**SITE PLAN REVIEW SHEET  
ENVIRONMENTAL VARIANCE REQUEST ONLY**

**CASE:** SP-2020-0274D

**PROJECT NAME:** 3336 Mount Bonnell

The applicant is requesting to vary from LDC 25-8-281(C)(2)(b) to allow construction of a boat dock within a 150-foot Critical Environmental Feature (CEF).

PROPOSED CONDITIONS DOCK  
LAYOUT/EROSION CONTROL

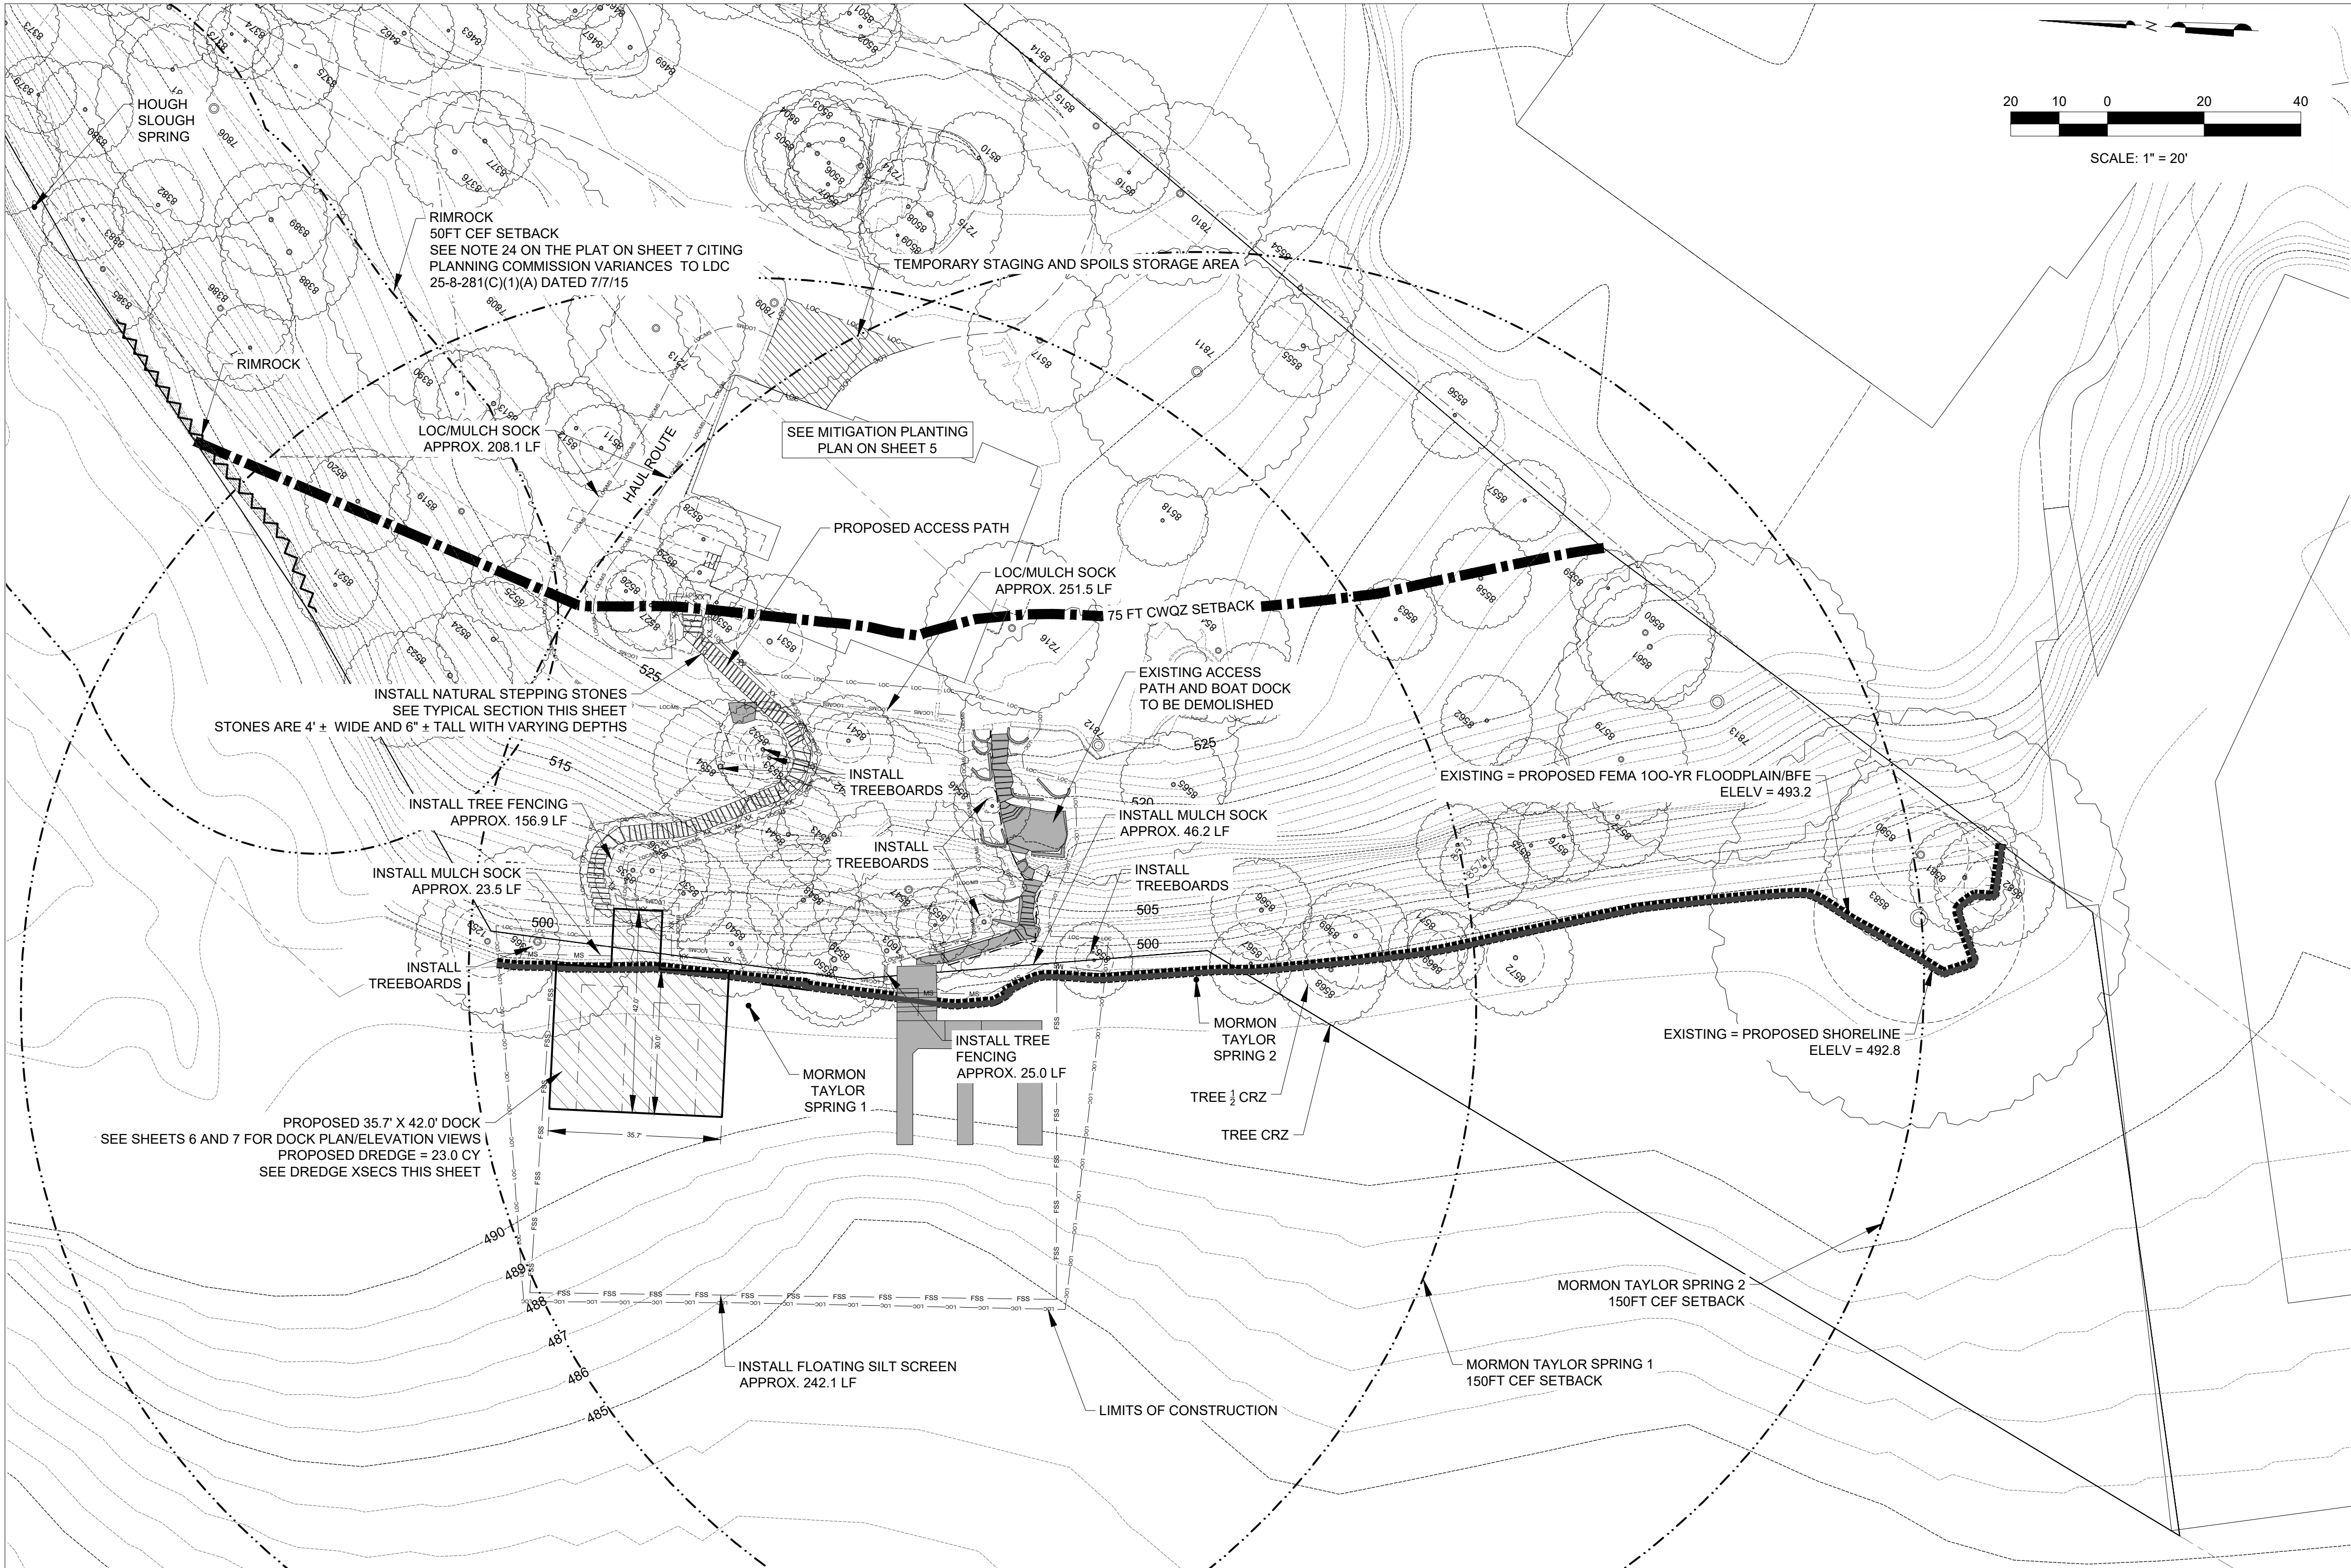
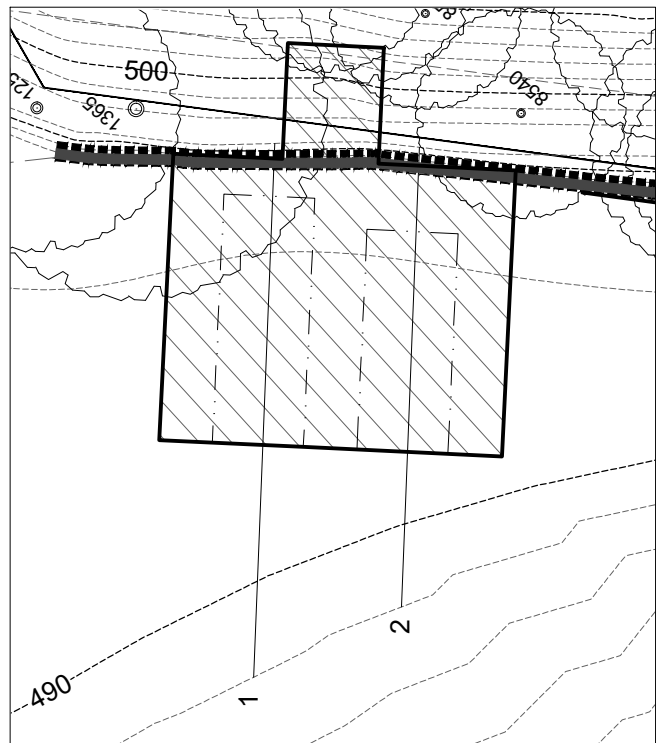
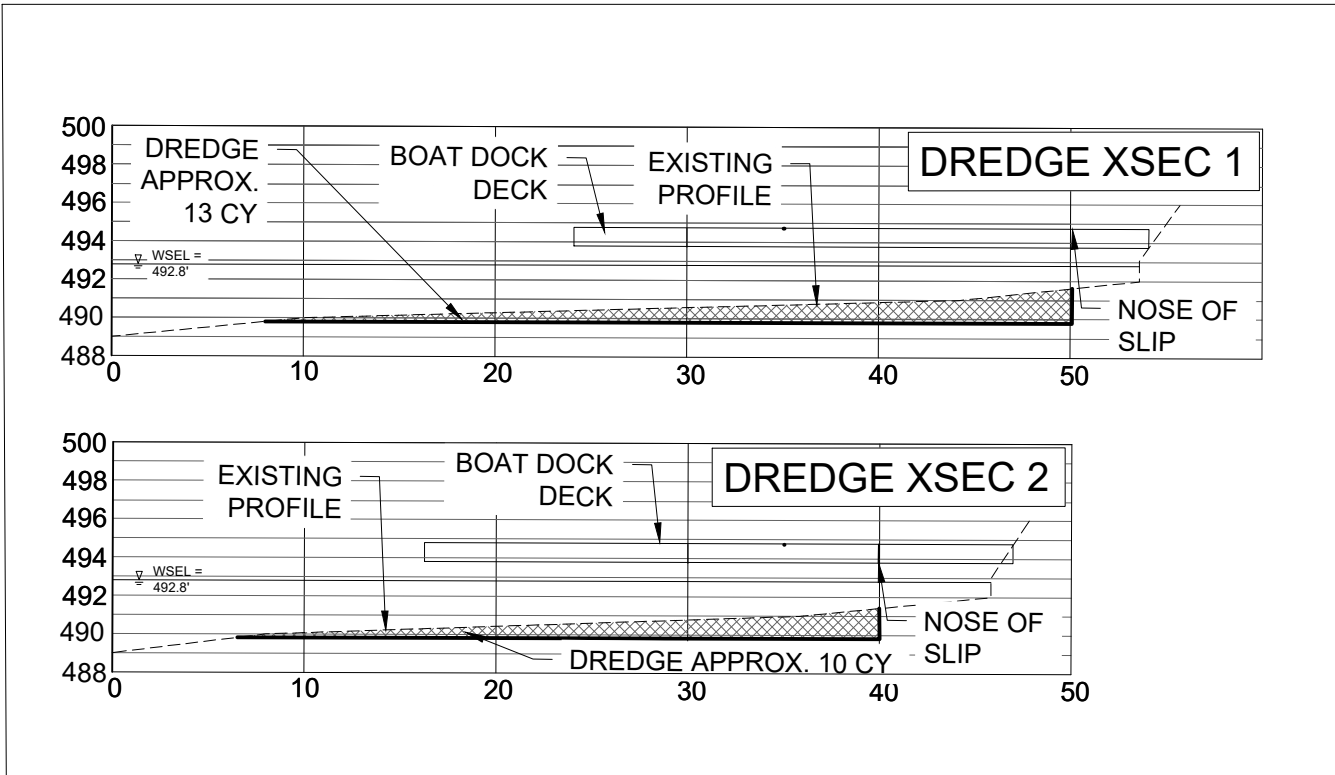
The findings of fact have been met, and staff recommends approval for construction within a 150 foot Critical Environmental Feature (CEF) with the following conditions:

- 1) Remove existing boat dock and access path as specified on plans;
- 2) Restore disturbed areas per City Standards Specification 609S.

**STAFF CONDITION:** Remove existing boat dock and access path as specified on plans; restore disturbed areas per City Standard Specification 609S.

**Yes. No disturbance of the spring CEFs is proposed. The springs were observed during a drawdown of Lake Austin by Watershed Protection Department staff and currently have no expression above the surface of the water. The new location of the dock is preferential as it has removed the dock from the area between the two springs which was described by staff in their notes as a spring horizon, which is multiple outlets of spring flow along an area.**

**Yes. The variance does not create significant harmful environmental consequences. Overland flow from the Limit of Construction will be treated by a sequence of erosion controls. Post construction, all disturbed areas will be revegetated per the City Standard Specification 609S.**
